### **Final Report - Corrections Required** **Application No. ANEX-24-0005**

**Description : Matrix Design Group on behalf of Colorado Springs Equities LLC is submitting a serial annexation petition for seven parcels and Land Use Plan/Rezoning exhibit for a portion of the subdivision known as Rock Creek Mesa.**

## ROCK CREEK MESA ADDITION NO. 5

<b>ROCK CREEK MESA ADDITION NO. 5</b>		
LOCATED IN SECTION 30, TOWNSHIP 15 SOUTH, RANGE 66 WEST OF THE 6TH P.M., COUNTY OF EL PASO, STATE OF COLORADO.		
CHECKED BY: JRB	SCALE: 1"=100'	DATE ISSUED: JANUARY 3, 2024
SHEET	2	OF 2

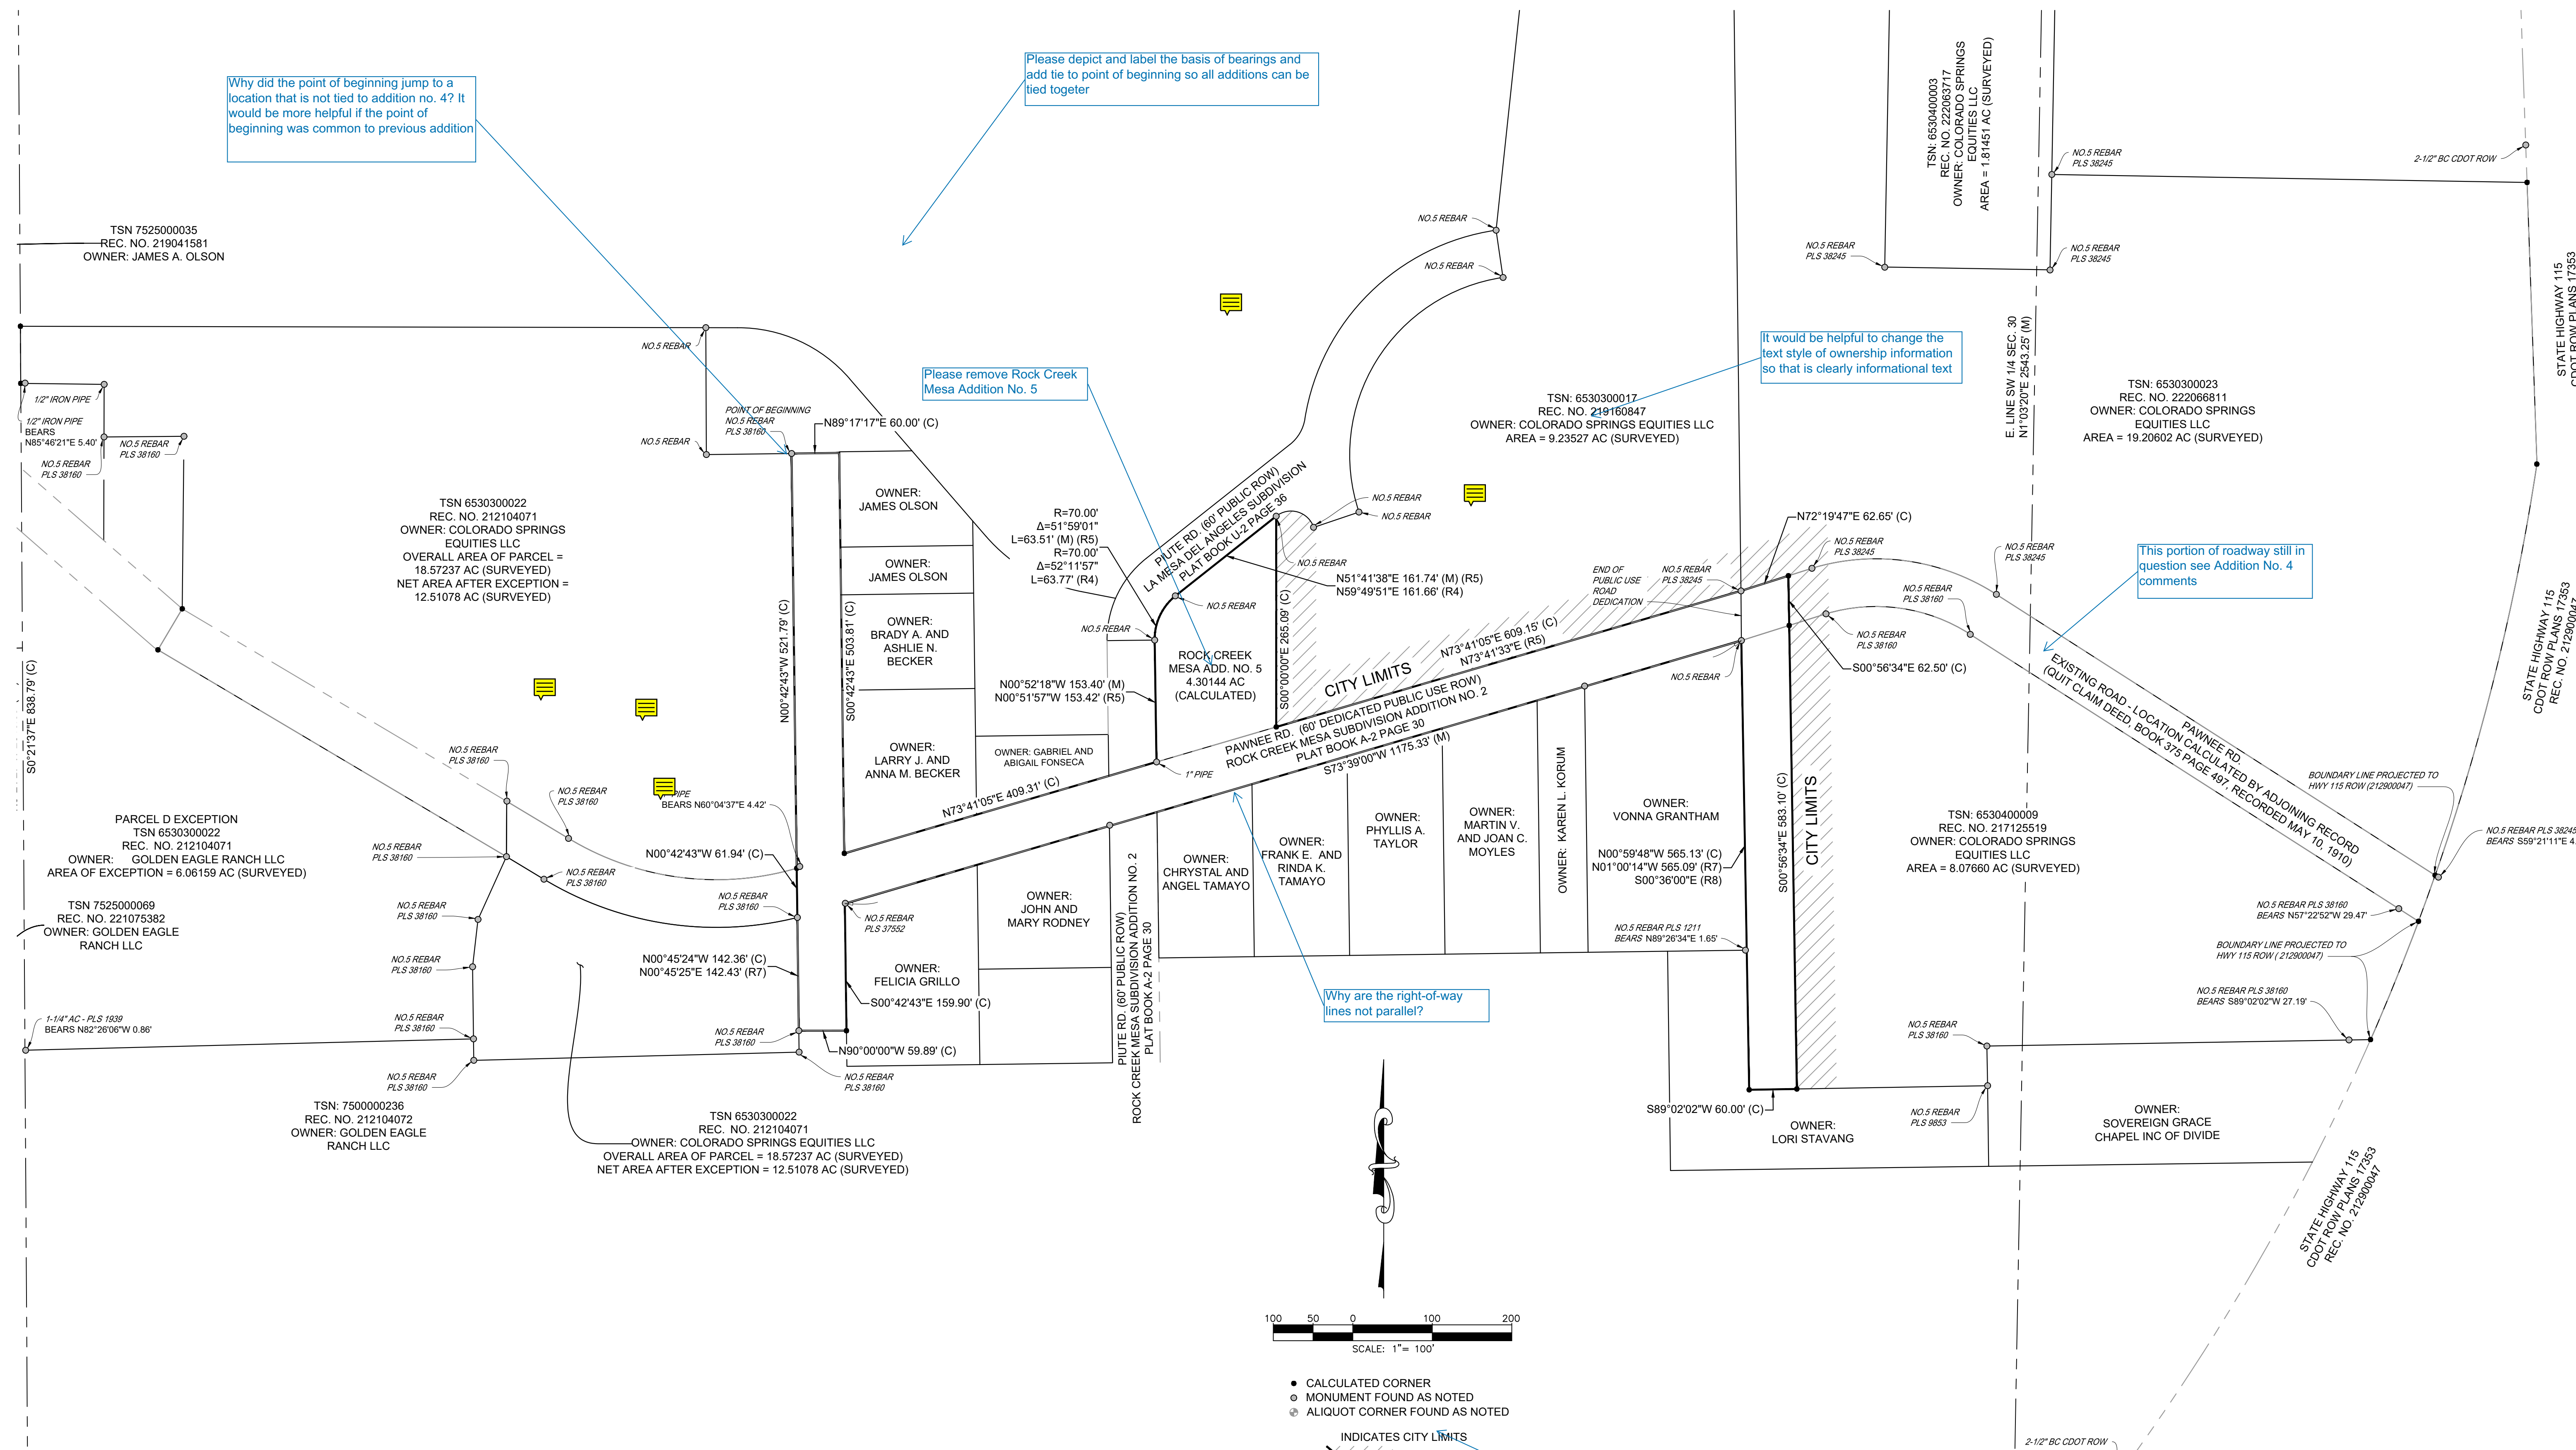
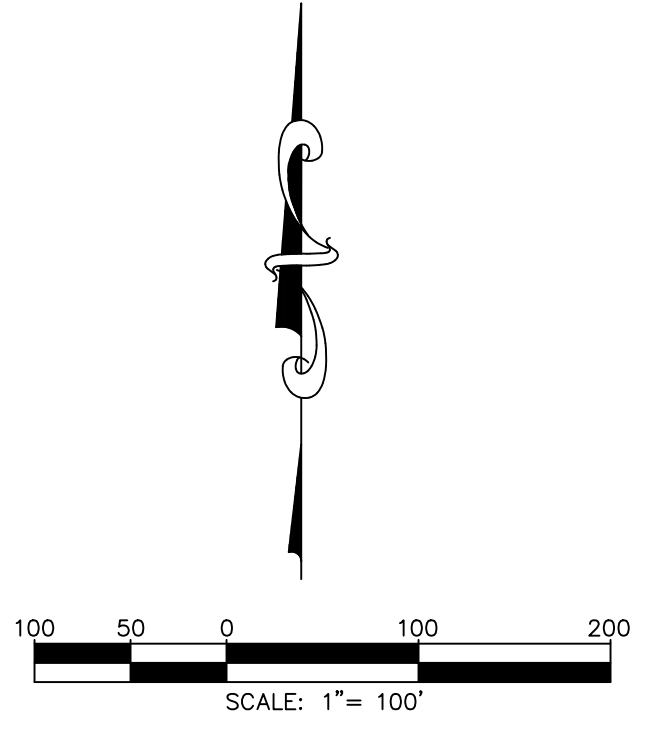
Why did the point of beginning jump to a location that is not tied to addition no. 4? It would be more helpful if the point of beginning was common to previous addition

Please depict and label the basis of bearings and add tie to point of beginning so all additions can be tied together

Please remove Rock Creek Mesa Addition No. 5

It would be helpful to change the text style of ownership information so that is clearly informational text

This portion of roadway still in question see Addition No. 4 comments

Why are the right-of-way lines not parallel?

Please add (M) and (C) to the legend
